Product Change Notification

Product Group: OPT/Thu Jun 6, 2024/PCN-OPT-1335-2024-REV-0

Standardization of Materials for PCB based 0402 and 0603 ChipLEDs

Chip size from 8mil to 7mil (InGaN)

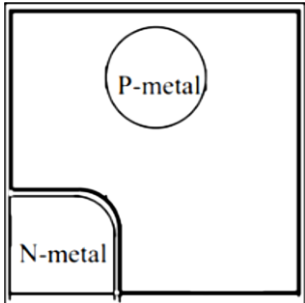
Affected parts: VLMB1500-GS08, VLMB1310-GS08

Chip size: 8 mil x 12 mil x 3.1mil	Chip size: 7mil x 9mil x 3.1 mil
P bonding pad size: Ø 3.9 mil	P bonding pad size: Ø 3.1 mil
N bonding pad size: Ø 3.5 mil	N bonding pad size: Ø3.3 mil
